Title: Permit 23-367: Forest Lake Hydraulic Dredging

Prepared by: Name: Veronica Sannes, Permitting Technician
Phone: 952-641-4580
vsannes@minnehahacreek.org

Attachment B: Permit Application Submittal

Re: **Wildhurst Trail Dredging Submittal**

Figure 1
**WILDHURST
DREDGING PROJECT
- SITE PLAN**

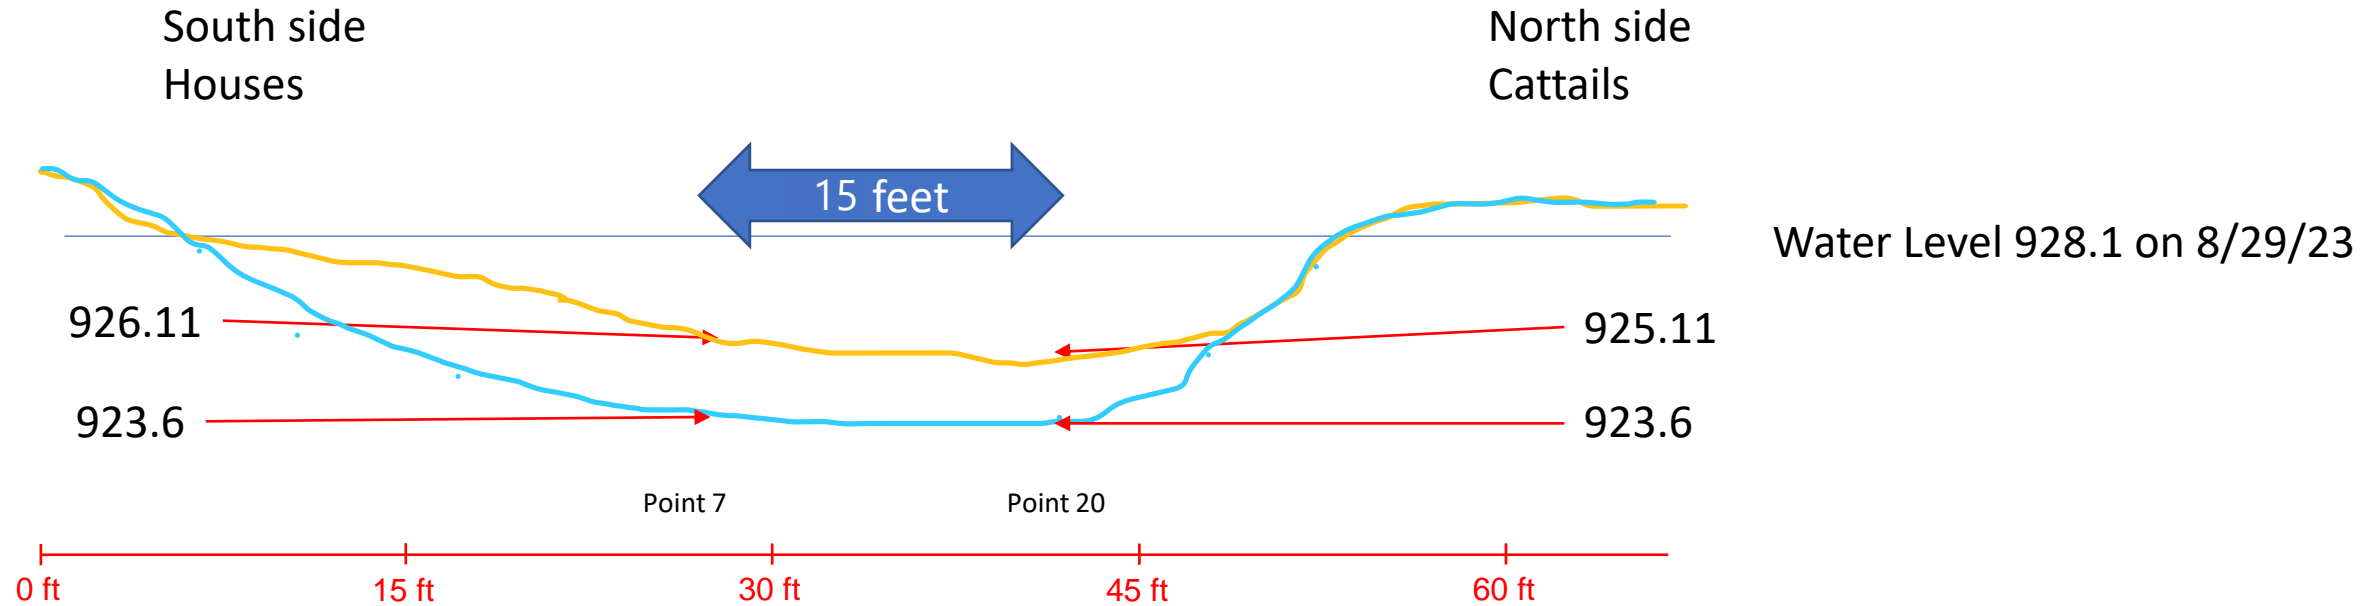
The channel is approximately 60 feet wide and 500 feet long. The Applicant proposes to dredge the channel over about 50 feet of its width, resulting in a 15-foot wide section with a bed elevation of 923.6 ft, sloping up to a bed elevation of 924.6 ft where there are boat parking structures. The northern side of the channel would have a 3:1 slope, while the southern side would have a more gradual incline. The existing depth of the bottom of the channel ranges from 924.61 ft to 926.78 ft (Appendix A of Attachment B).

Because the Applicant proposes that the geotextile bags be placed within the floodplain during the Project, MCWD staff and the MCWD Engineer evaluated this proposal for how this fill may impact the floodplain of Forest Lake (noting that it shares the Lake Minnetonka floodplain). Staff has determined that it would result in a temporary loss of floodplain storage that is less than a 0.001 ft (Appendix E of Attachment A) and therefore not a reason for concern.

Cross Section of Channel - Wildhurst

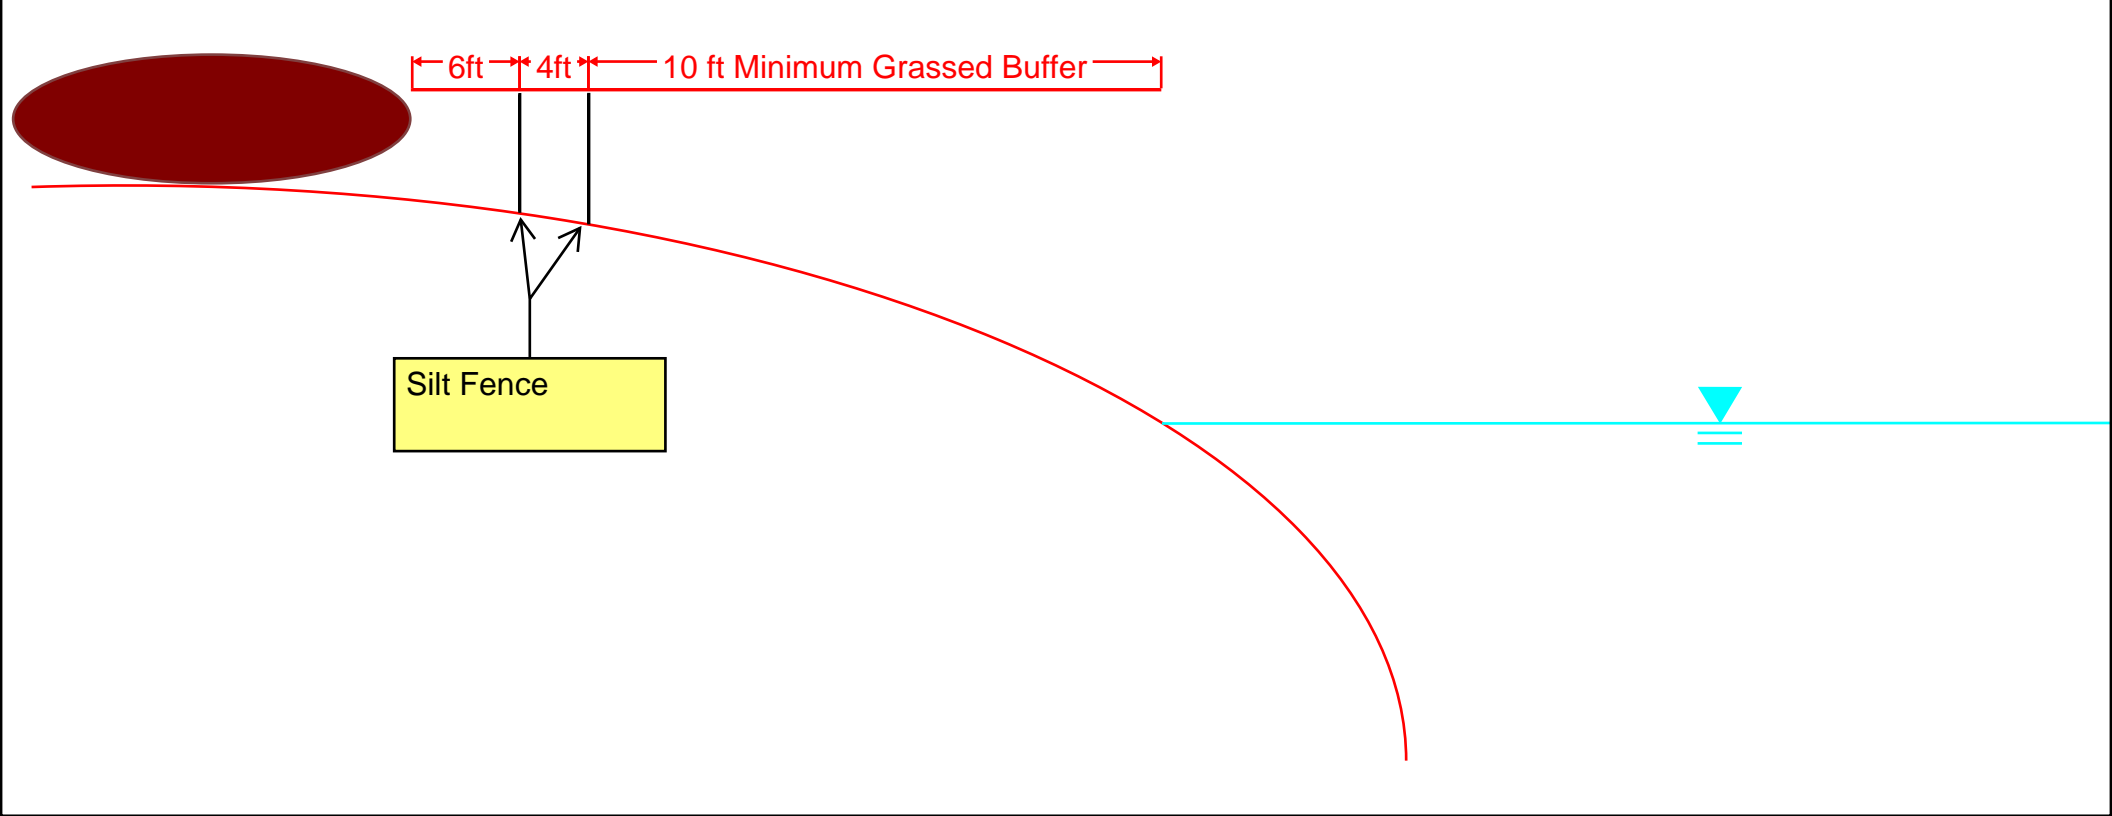
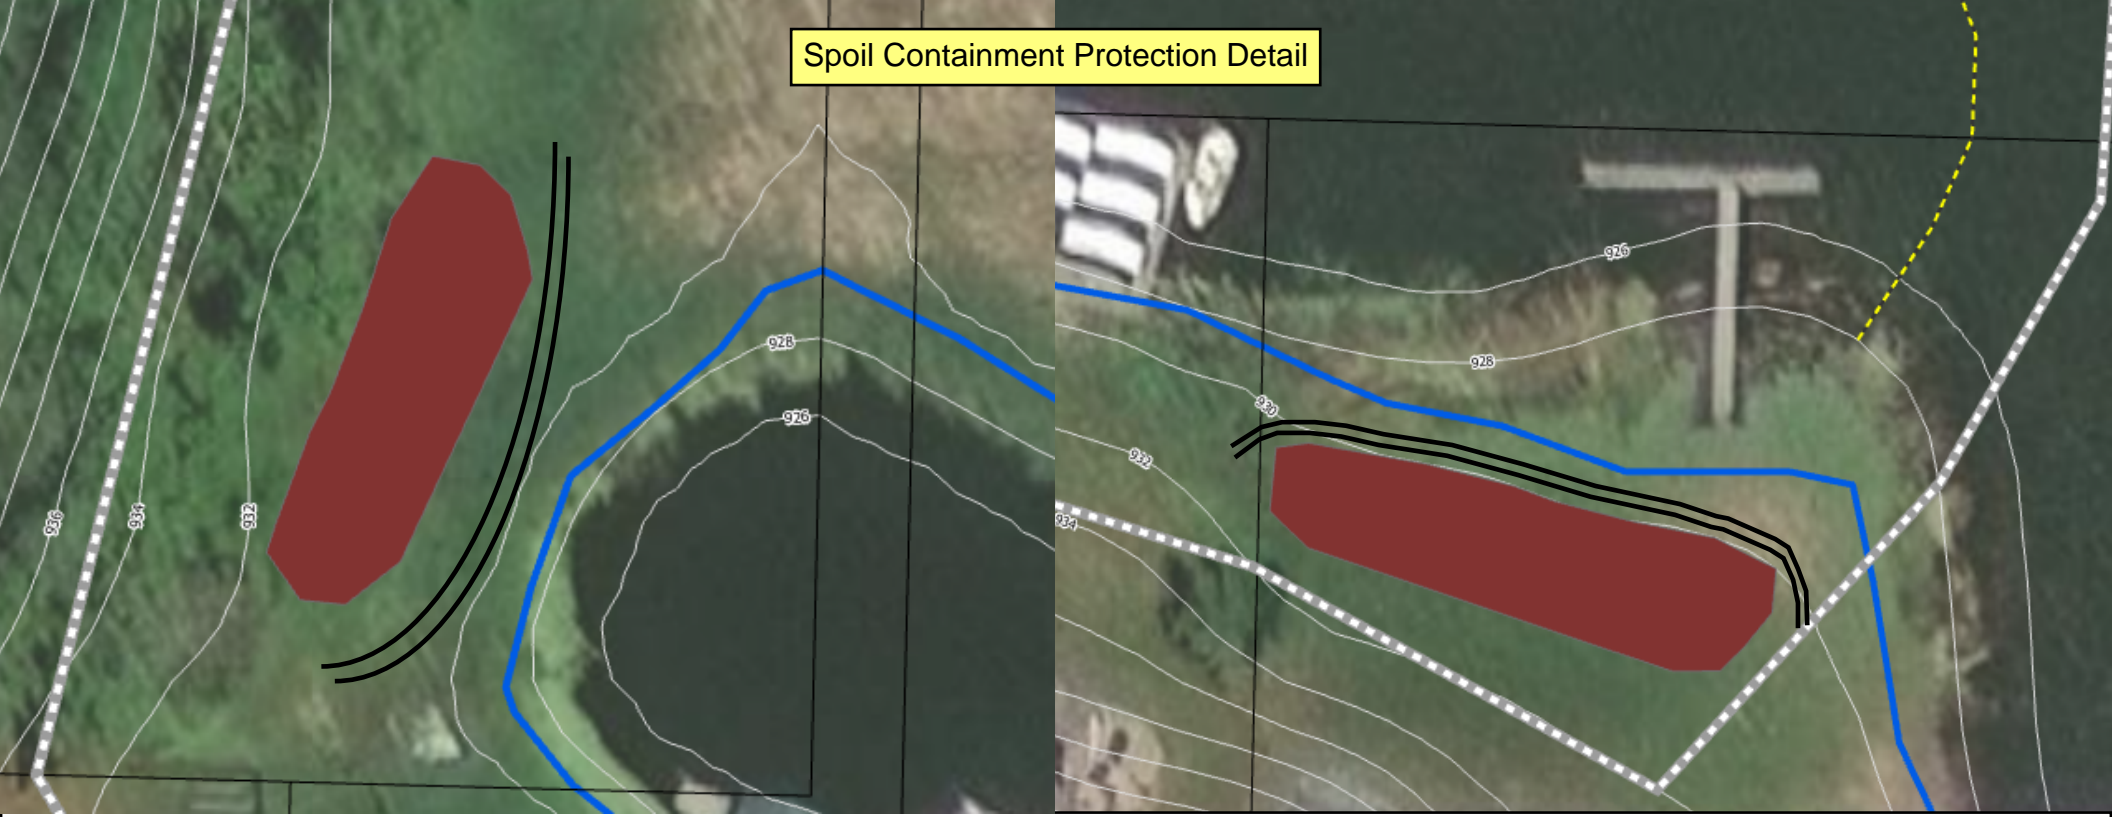
The existing channel is approximately 60 feet wide and maintains a relatively consistent width along its entire length. The Applicant does not propose to widen the entire channel but proposes to dredge a 15-foot section in the center, which will be at a depth of 923.6 feet.

4(c) Dredging is limited to the minimum dimensions necessary to achieve the purpose, but not below 923.6 in Lake Minnetonka (this incorporates the standard stated in the 1993 Joint Policy Statement among the MCWD, the Department of Natural Resources and the Lake Minnetonka Conservation District) or, in other lakes, four feet below the ordinary high-water elevation:

The Applicant proposes to dredge to an elevation of 923.6 feet. Forest Lake is hydraulically connected to Lake Minnetonka, and shares the Lake Minnetonka OHWL of 929.4 feet. For the purpose of applying this criterion, staff finds it appropriate to evaluate the dredging depth against the Lake Minnetonka criterion. The proposed dredging depth meets this criterion and is appropriate for the draft of the boats to be accommodated. The current sediment levels in the areas of the channel which will have the greatest change are 926.78 ft and the Applicant proposes to dredge to a depth of 923.6 ft.

4(d) Side slopes within dredged areas are to be 3:1:

The Applicant proposes a 3:1 slope on the northern side of the channel, with a more gradual slope on the southern side. MCWD staff and engineer find the more gradual slope to be of no concern, as the southern edge will likely be less susceptible to sediment sluffing as a result.
